## ADDENDUM #1

DATE: **July 3, 2018**

**Columbia Public Schools  
Hickman High CASA Building Renovations**

**PWA PROJECT NUMBER: 201621.15**

DRAWING NO.  
**ADD-1**  
 Sheet 1 of 2

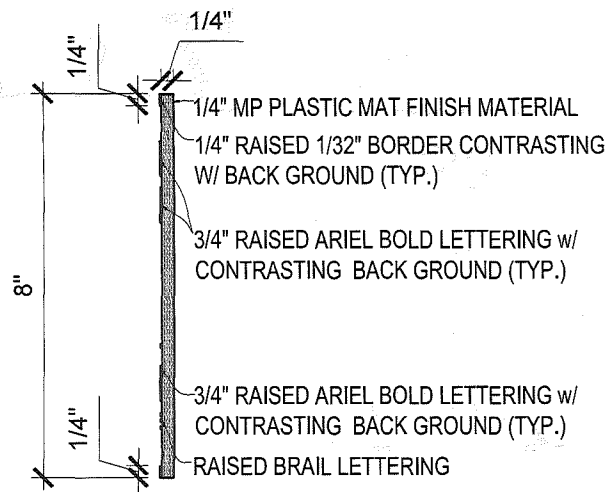
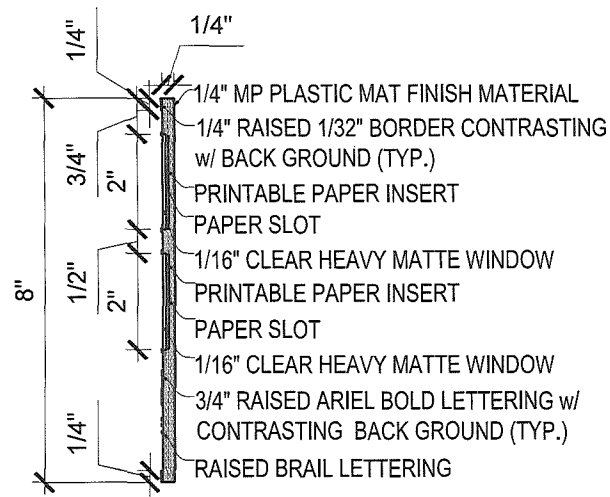
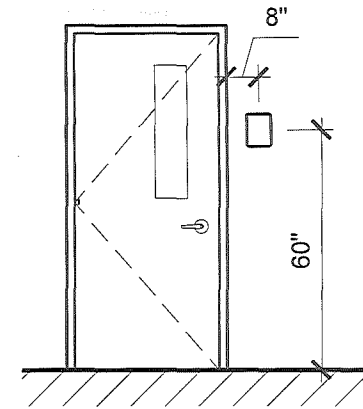
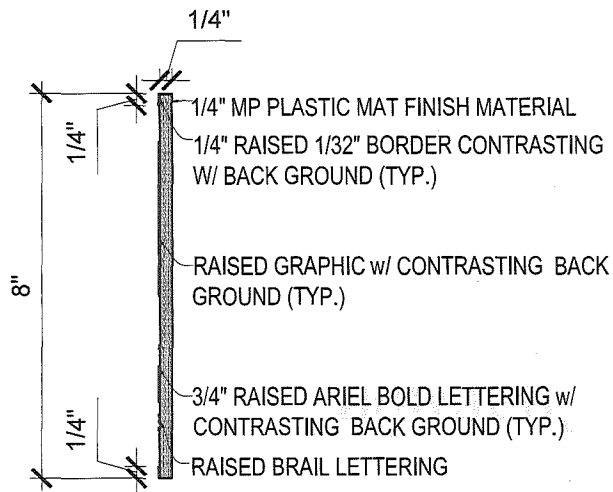
- 1. 8.5x11 – Restroom Signage and Classroom Signage.

Floor Plan Room No.	Sign text / Numbering Room Name	Sign Type	Quantity	Sign Copy
002	LAB	S2	1	"CLASSROOM"
003	ELECTRICAL ROOM	S1	1	
004	MEN' RESTROOM	S3	1	"BOYS"
005	WOMENS' RESTROOM	S4	1	"GIRLS"

Re: CPS-Hickman High CASA building renovations Addendum#1

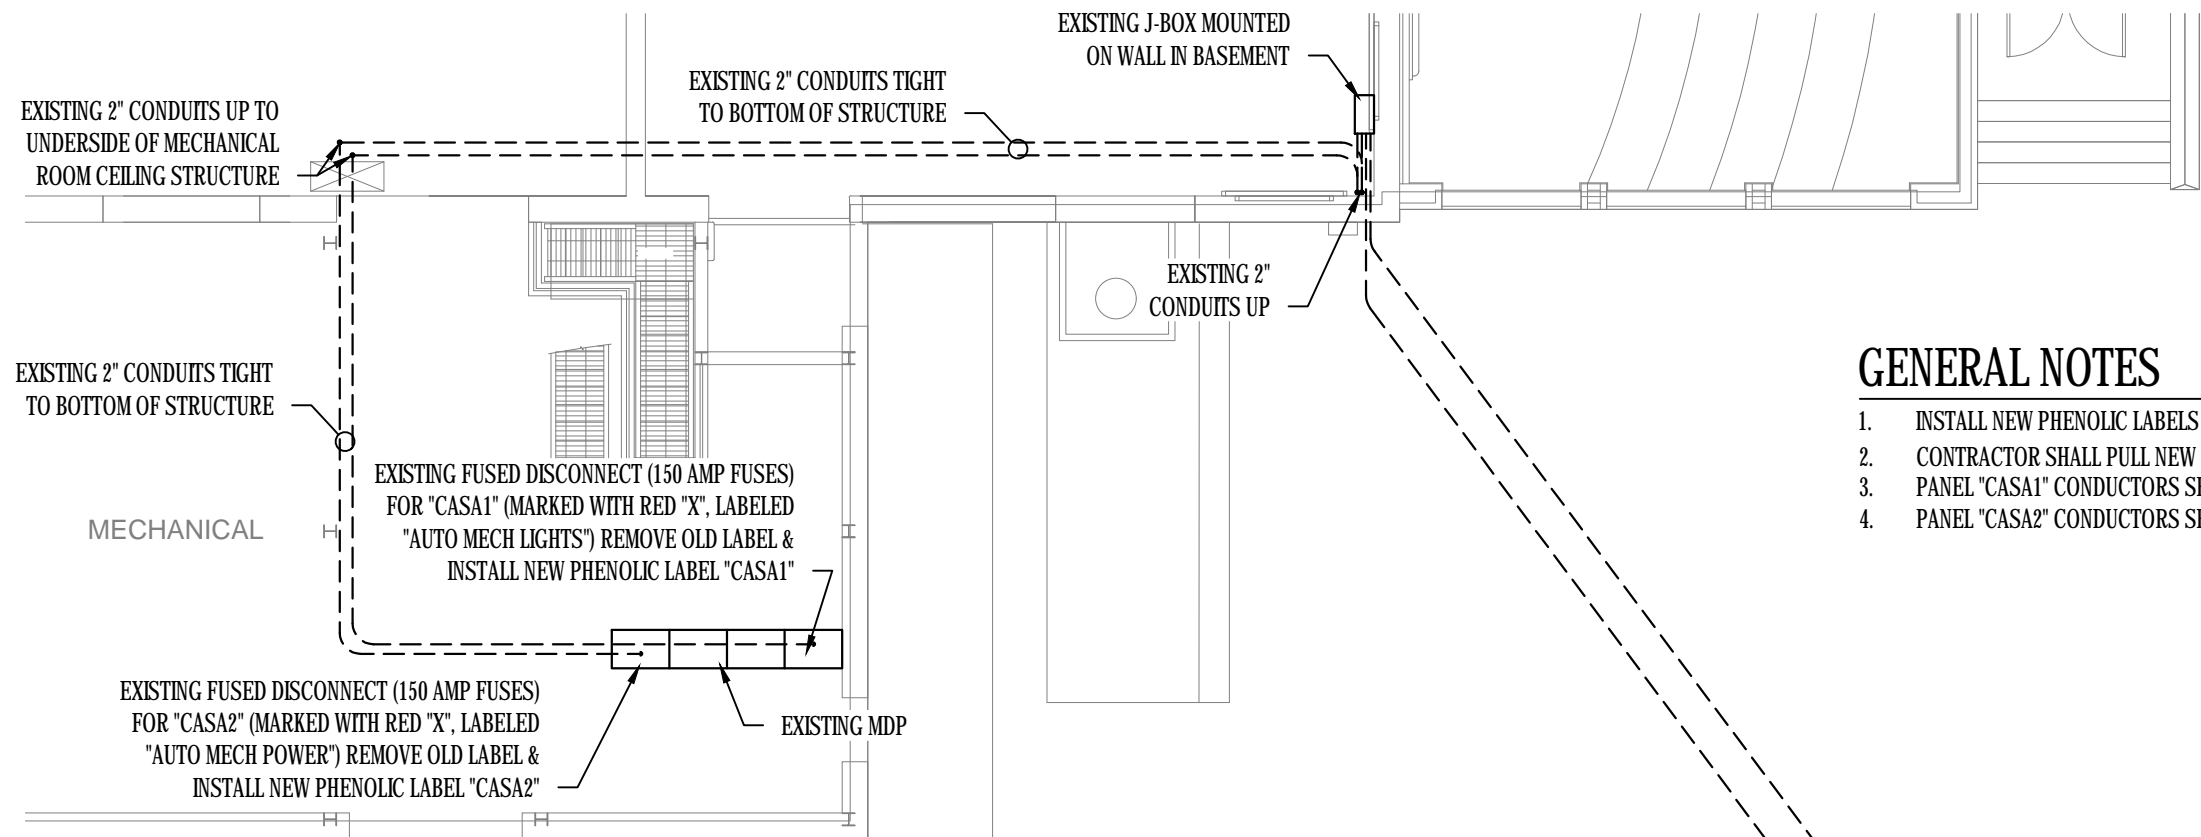
1. Existing LG VRF system shall be protected from debris during construction. After construction the ceiling cassette units shall have the coil cleaned, condensate drain / pan cleaned and the filters replaced.
2. Eye wash station shall have a 2" auto vent valve installed equal to Oatey "Surevent" 39016
3. New conductors must be run from existing panels labeled CASA1 & CASA2 back to existing main distribution panel. See attached exhibits to supplement sheet EP100 & sheet ED100.
4. Card readers and door position sensors shall be supplied and installed by CPS security contractor.

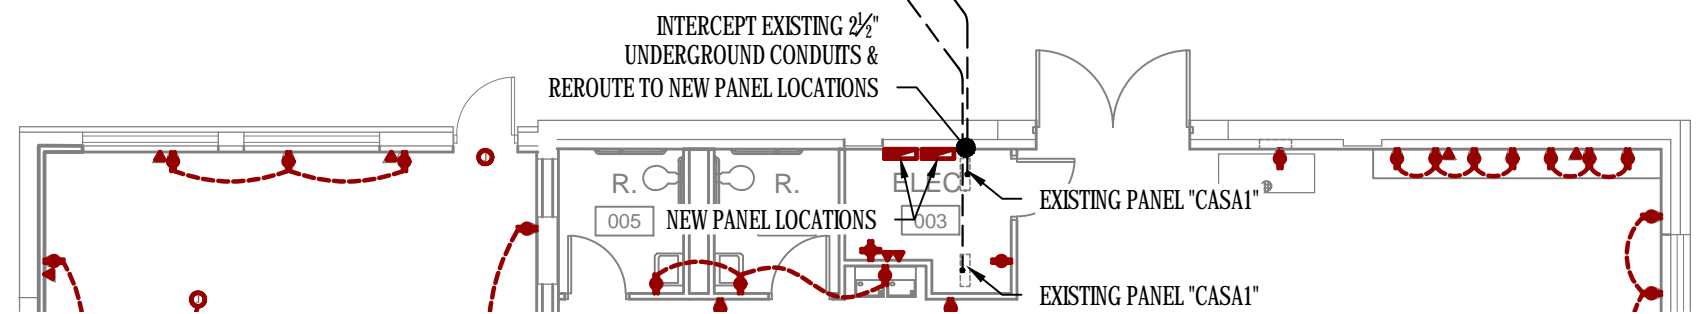
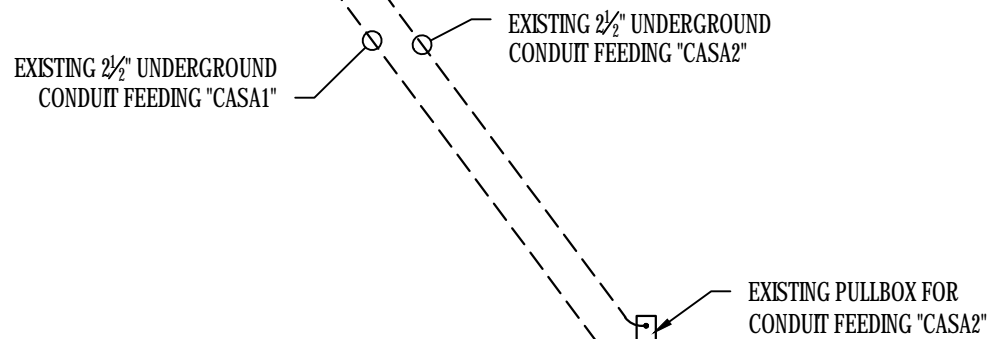
1. INSTALL NEW PHENOLIC LABELS ON PANELS "CASA1" & "CASA2".
2. CONTRACTOR SHALL PULL NEW CONDUCTORS IN EXISTING 2" & 2½" CONDUITS FROM "MDP" TO PANELS "CASA1" & "CASA2".
3. PANEL "CASA1" CONDUCTORS SHALL BE (3) #2/O COPPER & (1) #6 COPPER EQ. GRD.
4. PANEL "CASA2" CONDUCTORS SHALL BE (4) #2/O COPPER & (1) #6 COPPER EQ. GRD.
